From: [Sam Hunter Jones](#)
To: DraxRe-power@pins.gsi.gov.uk
Subject: Drax Re-power (EN010091) / IP ref: 20011838 - ClientEarth's Response to the Applicant's D7 submission + the ExA's request for info
Date: 28 March 2019 14:33:56
Attachments: [ClientEarth Response to Applicant's D7 Submission + ExA's RFI 28 March 2019.pdf](#)

Response to the Applicant's Deadline 7 submission and the Examining Authority's request for information in respect of Drax Re-power (App. No. EN010091)

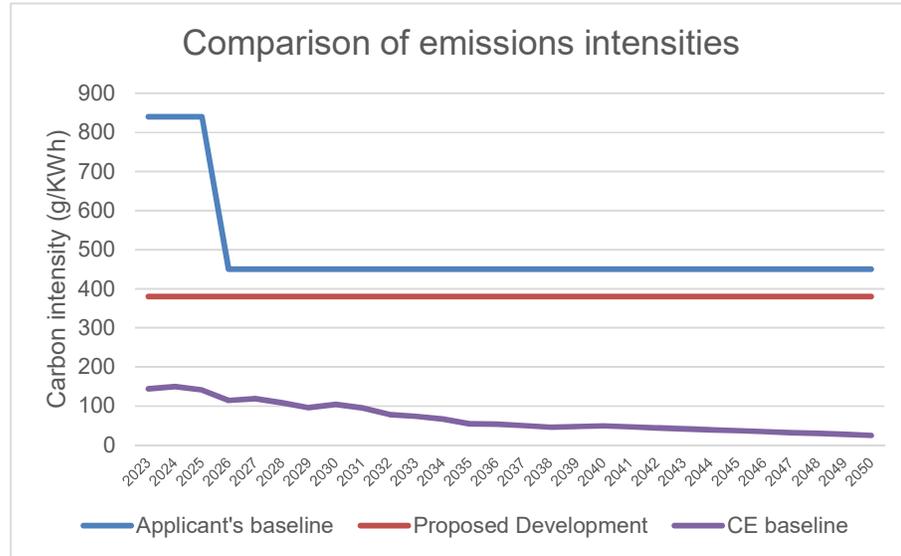
2. ClientEarth's climate impact assessment demonstrates the extent to which the Proposed Development would need to be constrained to be in step with the government's projections for power sector emissions, as depicted by the gap between the emissions intensities of the Proposed Development and the ClientEarth baseline in the below graph:²⁴
